31/6 10549 St. Paul St. HAWP 1-88

MEMORANDUM

Historic Area Work Permit for 10549 St. Paul Street, Kensington

The above referenced property, owned by Paula Mercer, was granted an historic area work permit (our number HAWP 1-88) on January 8, 1988, for the installation of an exterior stove pipe. At its January 21, 1988, the Historic Preservation Commission voted to amend the design of the chimney as shown on the attached. Please note this change in your record.

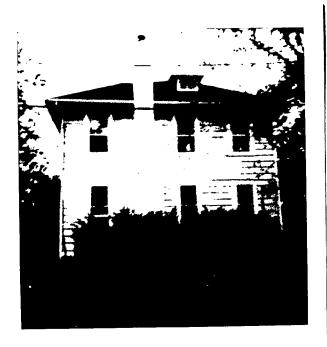
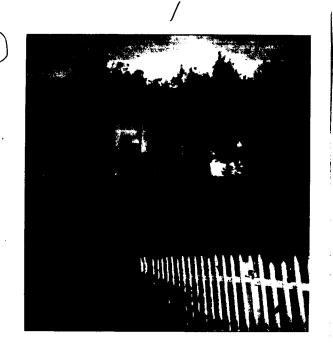
# 1,2,+3- metal stacks enclosed to the tom

# 4 - metal stack exposed

Our goal with the Paul Mercer chunney was to find the least obtrusive solution to adding a chirury to the house. The ruling to allow a simple MH. pipe was based on looking at other gas flues on houses and deciding that a sumple pipe, painted "out", would be least visible. By keeping the pipe tight to the main house mass, the pipe would tend to blend into the house. My opinion is that this theory is best served-even if the value board must wrap would the pipe-by holding the chinney within the Eave overhang. The proposal you described which is to hold the chimney flue away from the house and then to bend it seems to me to call attention to the chimney vather than make it "go away".

A simple joy in the vake board seems much simpler. At any vate we would be interested in the HPC valing.

Scale 14 = 11

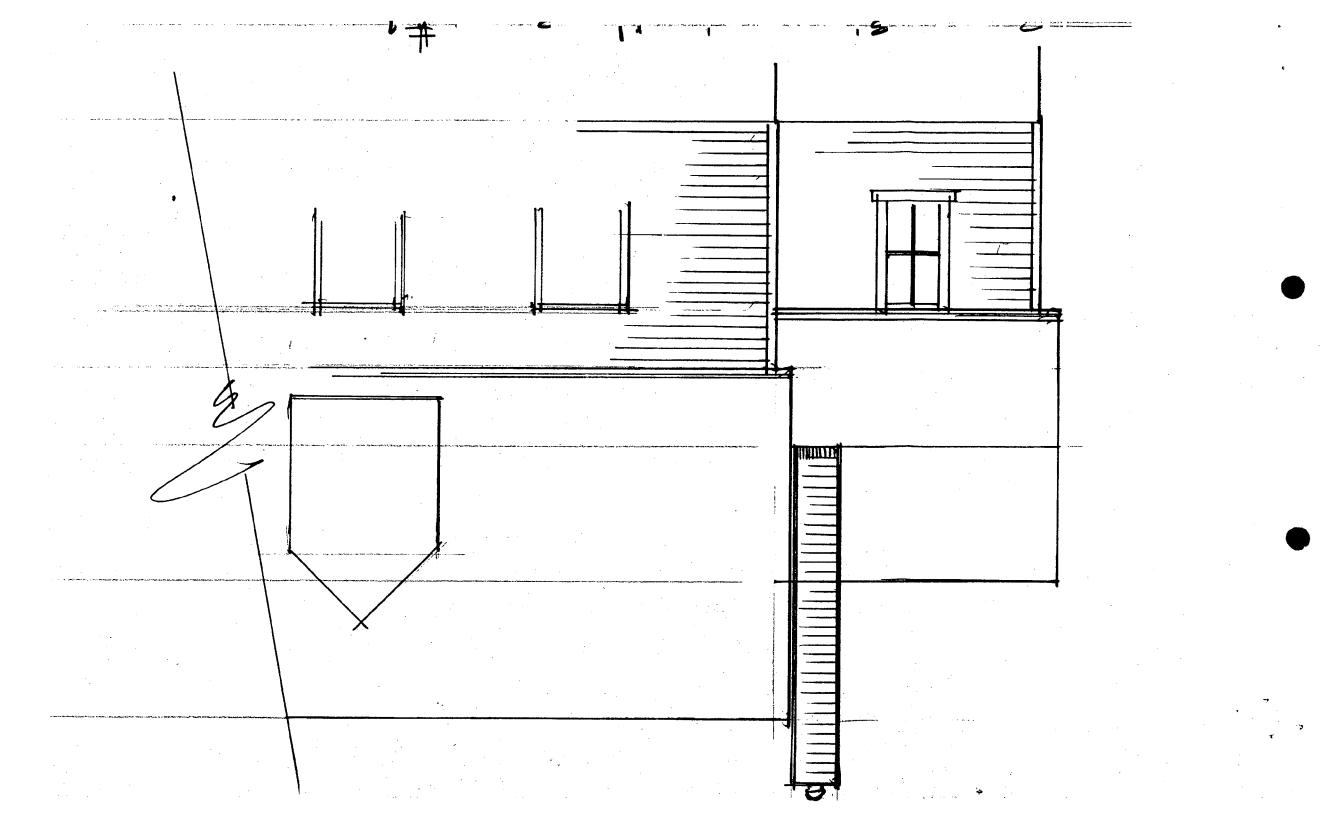
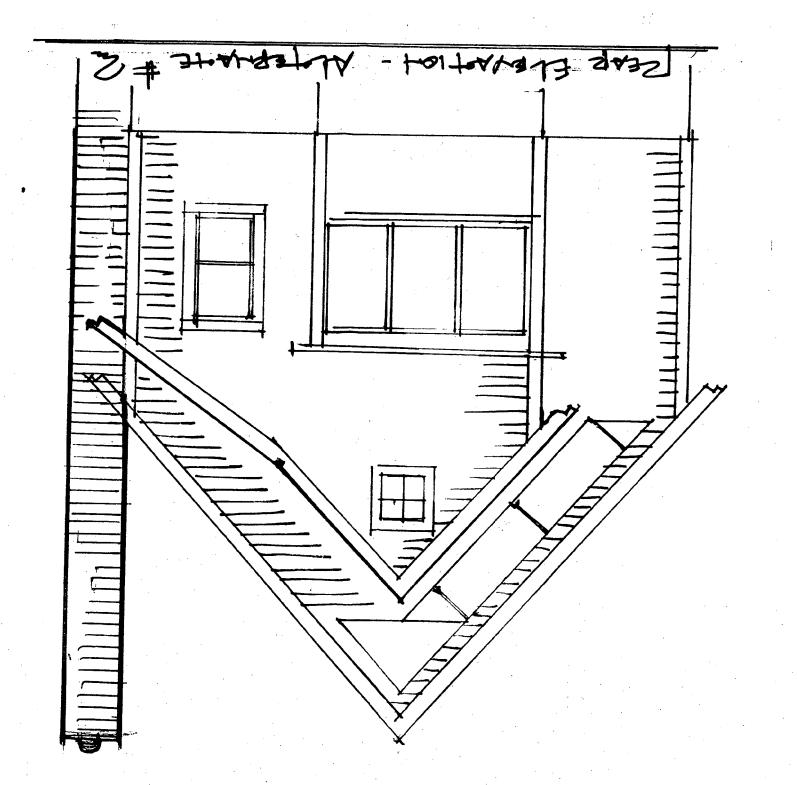
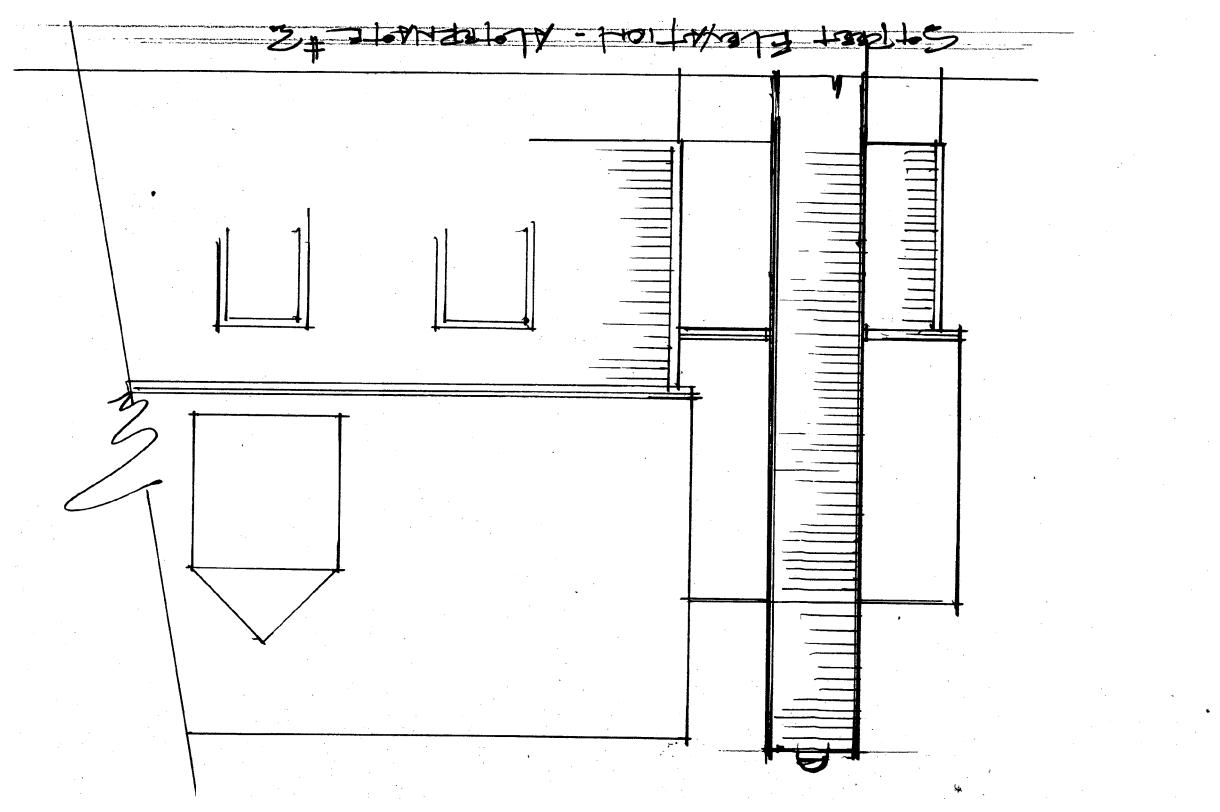
This application is to install a metal fireplace stack at the rear of the house which is a resource within the Kensington Master Plan historic district. The house is on the corner of St. Paul Street and Plyers Mill Road and the rear is highly visible from Plyers Mill Road. The Local Advisory Committee recommends approval of alternative #3 in which the stack is boxed in below the eave line and metal above the roof. Their reasoning is that the boxing itself is much more obtrusive than the plain metal above the roofline. (See photos of other example).

The HPC reviews enough of these metal chimneys so that it should consider adopting a policy to assure consistency. In the past you have approved: 1) no boxing-in required; 2) boxing-in all the way up (primarily on new construction); 3) masonry boxing required on new construction-in the Kensington historic district.

In this case I am concerned that the boxing will not fit neatly beneath the eave as shown in the drawing. If it does not it could be very awkward in appearance.

Stove pipe is to run straight up from its protrusion in the lower roof, parallel to wall of the house, and must  $\underline{not}$  break the eave line. It may be painted or not.
